TDECQ Considerations Revisited

Norman L. Swenson, Ph.D.

2 March 2026

Review of Cl 180.9.6.4

Figure 121-5—Illustration of the TDECQ measurement

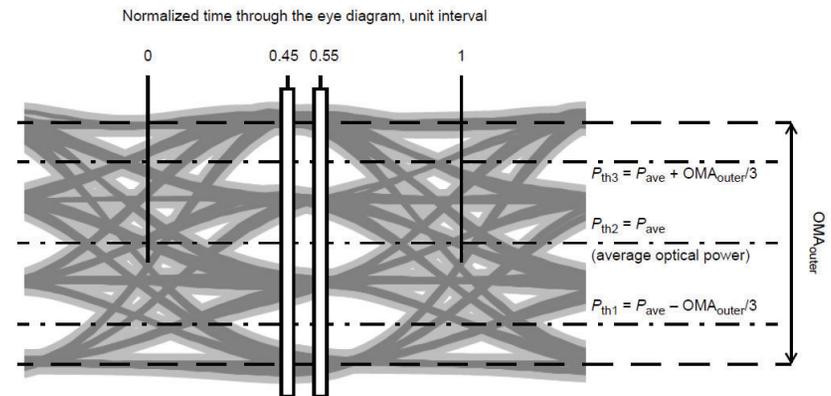
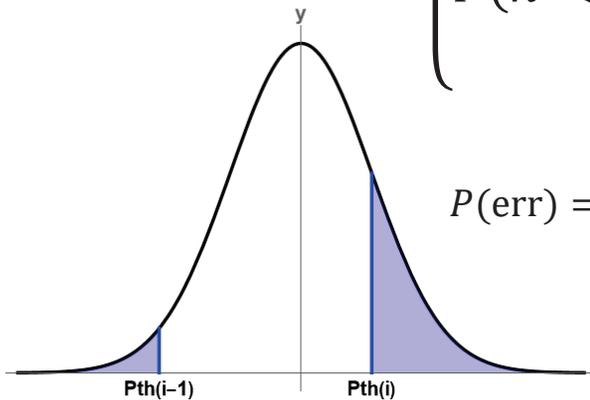
- Clause 180.9.6.4 does not compute symbol error rate this way
- Instead, clause 180.9.6.4 attempts to condition the probability of error on the value of the noise and then sum over the different noise values.

- It does this for each of three thresholds, then sums those three probabilities for the final probability of symbol error
- The two methods are not mathematically equivalent, because the tail of the gaussian distribution is being ignored at the largest magnitude y_k values

- Also, the method computes the probability of error for each threshold as though that were the only threshold (a binary decision). It double counts or triple counts errors, depending on the region that the sample is in.

- Depends also on the maximum magnitude y_k value considered
 - Depends critically on the grid density of the of y_i values in the discrete histogram
- This should be fixed for future readability and to ensure repeatability with different implementations

where n is Gaussian noise of the proper variance. The problem with this approach is when $y_i = y_{\max} \equiv \max\{y_i\}$

In that case, $\text{Prob}(T_1 \leq y \leq y_{\max})$ should not be weighted by $\text{Prob}(n = T_1 - y_{\max})$

Instead it should be weighted by $\text{Prob}(n \leq T_1 - y_{\max})$; otherwise we are ignoring the tail of the Gaussian distribution.

The second problem with the computation of symbol error probability in TDECQ is that it computes the probability of making an error by crossing $T1$, $T2$, and $T3$ independently, then adds those probabilities together to get a total probability. But this is double or triple counting in some cases, since a given y value has a certain probability of crossing one (or sometimes two, if an internal region) thresholds, and it does not make another symbol error if it crosses the next threshold.

All of these problems could be avoided by using the more conventional error probability conditioned on the value of y and then using the Q function to determine the probability of crossing a threshold out of the original zone.
